TITLE - DOOR AUTOMATION

DWG NO - NTPL- 327

NAME	SIGNATURE	DATE		
DRAWN	B.S.		06-02-2026	PRODUCT - MOTORIZED ROLLING SHUTTER	
CHK'D	V.T.		06-02-2026	PROJECT NO - NTPL- 327	REVISION - 00
APPV'D	V.T.		06-02-2026	SITE LOCATION - PUNE	WEIGHT -
				MATERIAL -	QTY -01
IF ANY QUERIES CONTACT - Design2@nihva.com				PROJECTION METHOD	SCALE :
ALL DIMENSIONS ARE IN 'MM'			A2		SHEET 1 OF 1

DRAWING

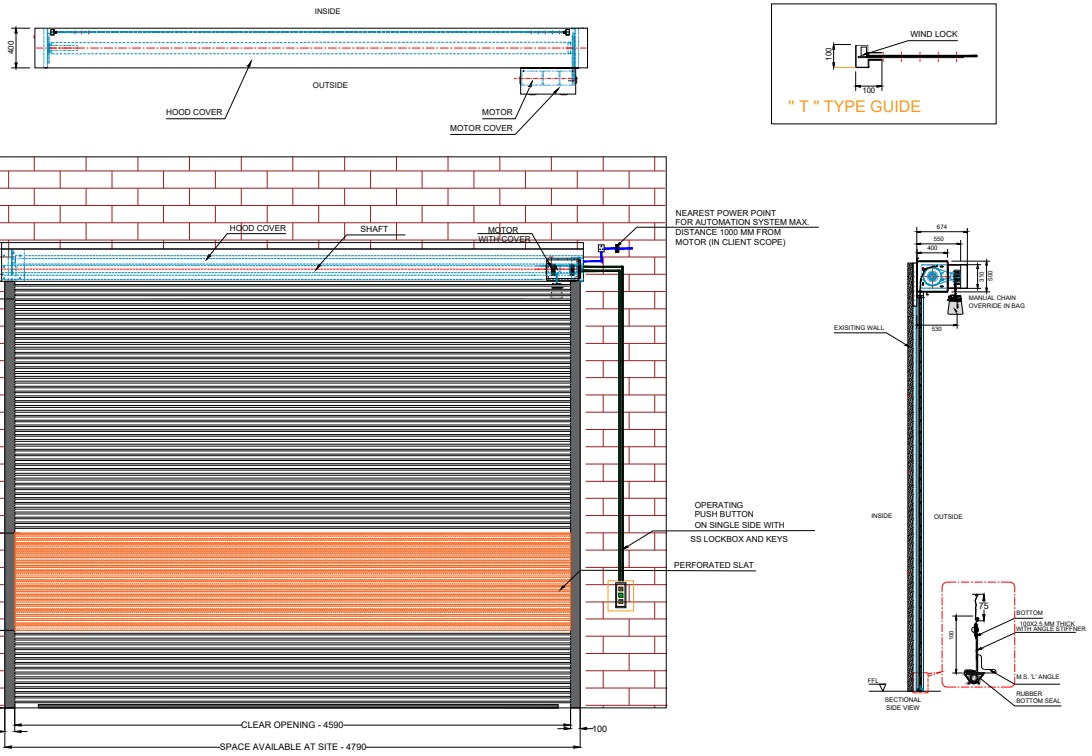
CONSIDERING THE LARGE DOOR SIZE (7400X4690 MM) & THE INCREASED CLEAR HEIGHT,THE DOOR WILL BE EXPOSED TO HIGHER WIND PRESSURE.TO ENSURE SAFE,SMOOTH,& RELIABLE OPERATION OVER ITS SERVICE LIFE, THE FOLLOWING MEASURES ARE RECOMMENDED:

1) PERFORATED SLAT IS RECOMMENDED BETWEEN THE SHUTTER TO PROVIDE ADDITIONAL STRENGTH & STABILITY DOOR.
2) SAFETY CATCH ARRANGEMENT NEED TO CONSIDERED TO PREVENT ACCIDENT IN CASE OF FAILURE IN DRIVE SYSTEM, ENSURING MAXIMUM SAFETY TO PERSONNEL & EQUIPMENT.
